Form 3160-5 (June 2019)

1. Type of Well Oil Well Gas V	Vell Other		8. Well Name and No	O. TWEETY BIRD 17 FED COM/502H		
2. Name of Operator EOG RESOURG	CES INCORPORATED		9. API Well No. 30-0)25-51768		
	BY 2, HOUSTON, TX 77(3b. Phone No. (713) 651-70	(include area code)	10. Field and Pool or CRUZ; BONE SP	Exploratory Area

Update casing and cement program to current design.

Revised Permit Information 07/26/2023:

2246' FNL Revised Wellbore A: KB: 3734' 1079' FWL GL: 3709'

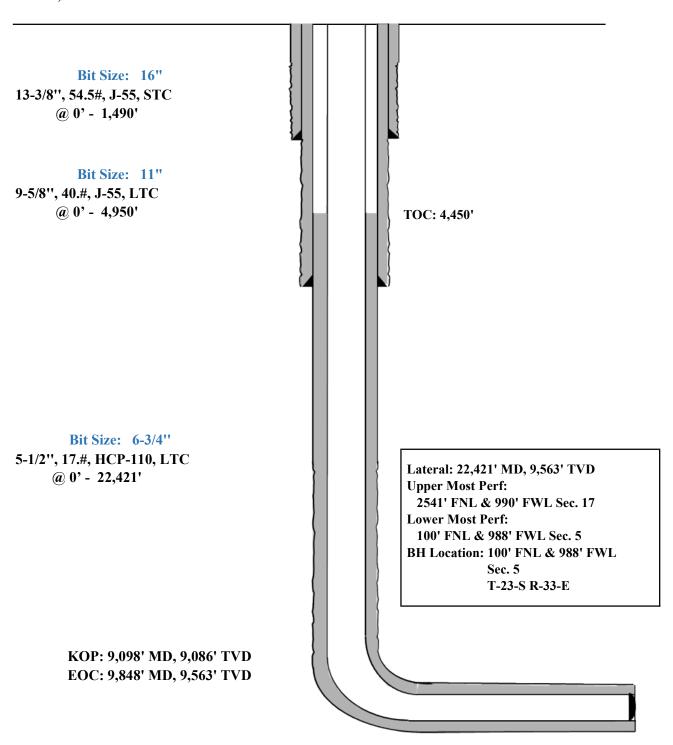
Casing Program A:

Hole	Interv	al MD	Interva	al TVD	Csg			
Size	From (ft)	To (ft)	From (ft)	To (ft)	OD	Weight	Grade	Conn
16"	0	1,490	0	1,490	13-3/8"	54.5#	J-55	STC
11"	0	4,967	0	4,950	9-5/8"	40#	J-55	LTC
6-3/4"	0	22,421	0	9,563	5-1/2"	17#	HCP-110	LTC

Variance is requested to waive the centralizer requirements for the 9-5/8" casing in the 11" hole size. An expansion additive will be utilized, in the cement slurry, for the entire length of the 11" hole interval to maximize cement bond and zonal isolation.

Variance is also requested to waive any centralizer requirements for the 5-1/2" casing in the 6-3/4" hole size. An expansion additive will be utilized, in the cement slurry, for the entire length of the 6-3/4" hole interval to maximize cement bond and zonal isolation.

EOG requests permission to allow deviation from the 0.422" annulus clearance requirement for the intermediate (salt) section from Onshore Order #2 under the following conditions:

2246' Revised Wellbore B: KB: 3734' GL: 3709'

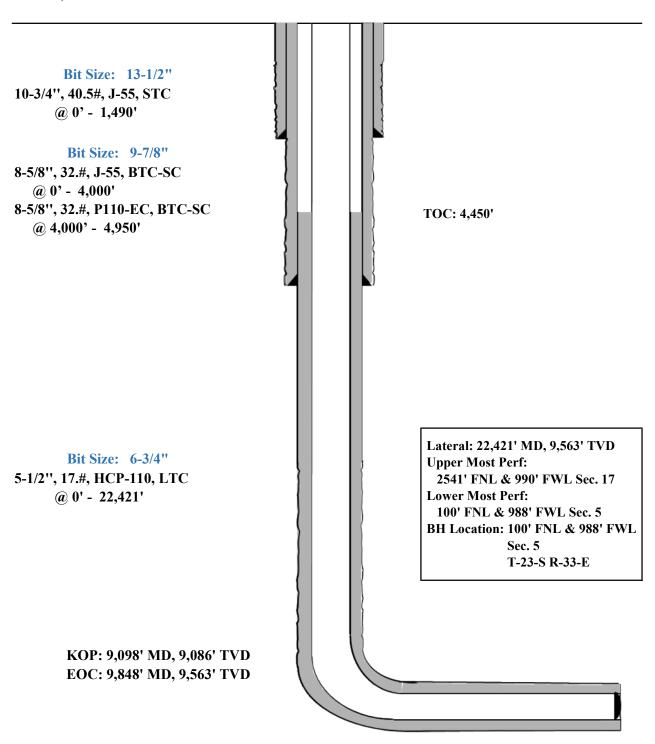
Casing Program B:

Hole	Interval MD		Interval TVD		Csg			
Size	From (ft)	To (ft)	From (ft)	To (ft)	OD	Weight	Grade	Conn
13-1/2"	0	1,490	0	1,490	10-3/4"	40.5#	J-55	STC
9-7/8"	0	4,013	0	4,000	8-5/8"	32#	J-55	BTC-SC
9-7/8"	4,013	4,963	4,000	4,950	8-5/8"	32#	P110-EC	BTC-SC
6-3/4"	0	22,421	0	9,563	5-1/2"	17#	HCP-110	LTC

Variance is requested to waive the centralizer requirements for the 8-5/8" casing in the 9-7/8" hole size. An expansion additive will be utilized, in the cement slurry, for the entire length of the 9-7/8" hole interval to maximize cement bond and zonal isolation.

Variance is also requested to waive any centralizer requirements for the 5-1/2" casing in the 6-3/4" hole size. An expansion additive will be utilized, in the cement slurry, for the entire length of the 6-3/4" hole interval to maximize cement bond and zonal isolation.

EOG requests permission to allow deviation from the 0.422" annulus clearance requirement for the intermediate (salt) section from Onshore Order #2 under the following conditions:

Proposed 11" Hole with 9.625" 40# J55/HCK55 LTC Casing

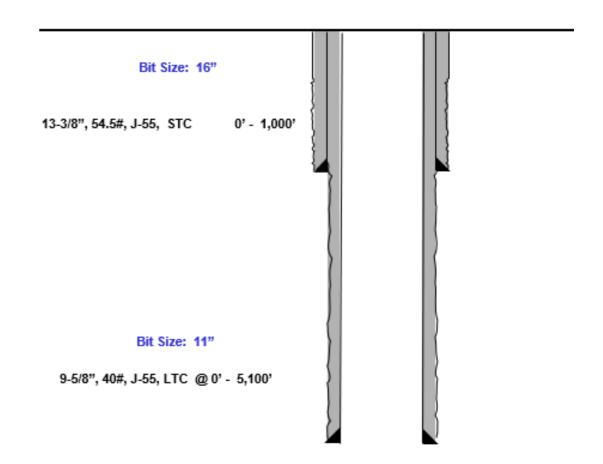
- 11" Bit + 0.52" Average hole enlargement = 11.52" Hole Size
 - 0.9475" Clearance to casing OD

• 0.4475" Clearance to coupling OD

Proposed 9.875" Hole with 8.625" 32# J55/P110 BTC-SC Casing

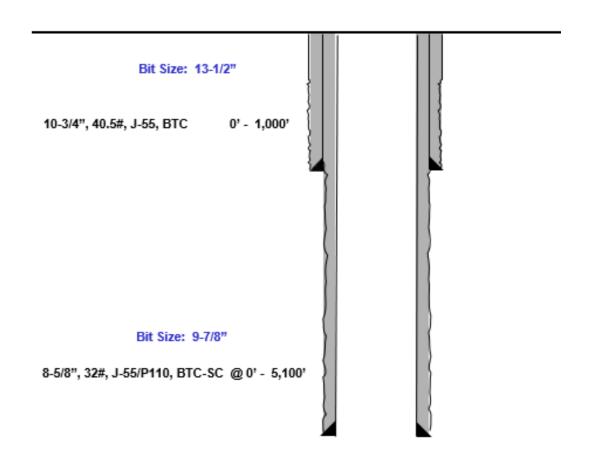
- 9.875" Bit + 0.42" Average hole enlargement = 10.295" Hole Size
 - 0.835" Clearance to casing OD

• 0.585" Clearance to coupling OD
